## DPR 25-20: Avon Retail Shops

Planning & Building Department Staff Report

For Hearing on February 23, 2026

Plan Commission, Public Hearing

## Exhibit D – Building Elevations Building A

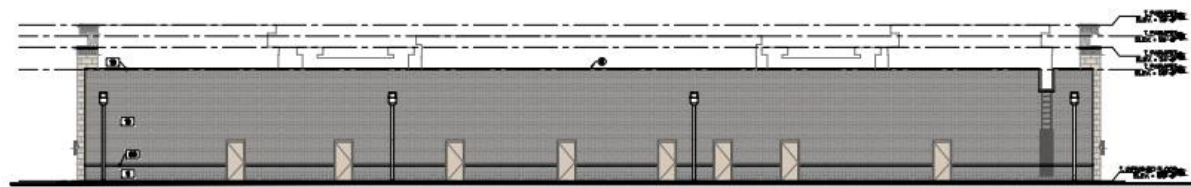
The proposed percentage of brick ranges from 36% on the front façade to 97% on the rear façade. Therefore, the overall

<p>appearance of the buildings will meet the intent of the UDO for having high-quality materials. While the front façade does not meet the 80% requirement, the change of materials offers a superior visual interest to warrant a deviation from the brick standard.</p> <p><b>Staff recommends approval of this waiver request.</b></p>
<ul style="list-style-type: none"><li><b>RECOMMENDATION</b></li></ul>	<p>Staff finds that the overall development plan would be consistent with the standards of the UDO. Therefore, if the requested waivers are approved, <b>staff recommends approval of petition DPR 25-20: Avon Retail Shops, subject to the following conditions:</b></p> <ol style="list-style-type: none"><li>1. Prior to issuance of a building permit, a subdivision plat must be filed and approved to combine the properties into one lot.</li><li>2. Any revised plans must comply with all commitments and conditions noted as part of any approval granted.</li><li>3. A landscape bond is required per Section 6.1(D)(3) of the Unified Development Ordinance. This bond must be provided to the Town of Avon prior to the issuance of a full Certificate of Occupancy for the subject site.</li><li>4. The development shall comply with all relevant portions of Town Code, the necessary approval by Crossroad Engineers on behalf of the Town, and comments by Public Works, the Fire Department, and Crossroad Engineers at the preconstruction meeting.</li></ol>
